Access Compliance Report

Public Rights-of-Way

(Curb Ramps)

Intersection ID: 10027081	Main Street: GALLERIA_BV	Cross Street: N/A	Location: NW
ADA ID: 759B90236B00	Ramp Type: PerpDiag	Initial Pass/Fail: Fail	Overall Compliance: No
		Severity Score: 8.75

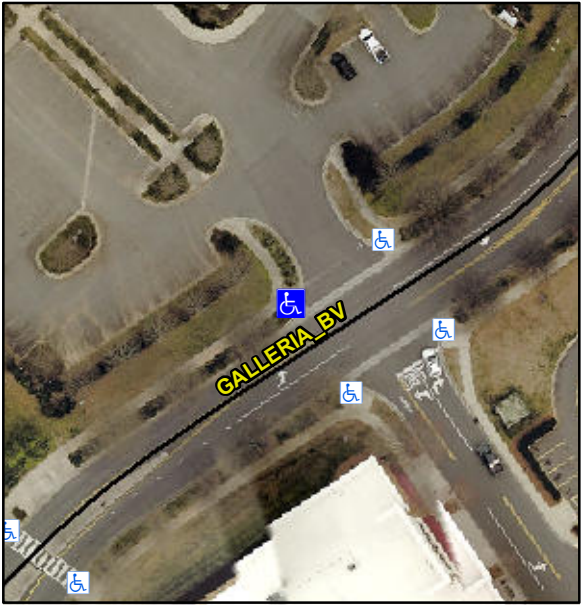
Codes/Mitigation Info/Possible Solution			Field Measurements/Component Compliance		
	Possible Solutions:		Compliance	Description	Data
	Remove & Replace Curb Ramp With Two New Directional Ramps or Equivalent.		Yes	Ramp Length (in)	96.0
			No	Ramp Width (in)	38.3
			N/A	Flare Type LT	N/A
			N/A	Flare Slope LT (%)	N/A
			N/A	Flare Traversable LT?	N/A
			N/A	Landing Length (in)	N/A
			N/A	Landing Width (in)	N/A
			N/A	Landing Slope (%)	N/A
			N/A	Landing X Slope (%)	N/A
			N/A	Landing Curb? (Y/N)	N/A
			N/A	Shared Landing?	N/A
			N/A	Gutter Ponding?	N/A
			N/A	Gutter Lip Ht (in)	N/A
			No	Painted X Walk1?	N/A
				X Walk 1 Direction	To SE
			N/A	X Walk 1 Width (in)	N/A
				X Walk 1 Slope (%)	1.3
				X Walk 1 X Slope (%)	0.7
			N/A	Ramp inside XWalk1?	N/A
<p>Surveyor Notes:</p> <p>N/A</p> <p>PROW/ADA:</p> <p>R304.5.1</p>			N/A	Ramp inside XWalk2?	N/A
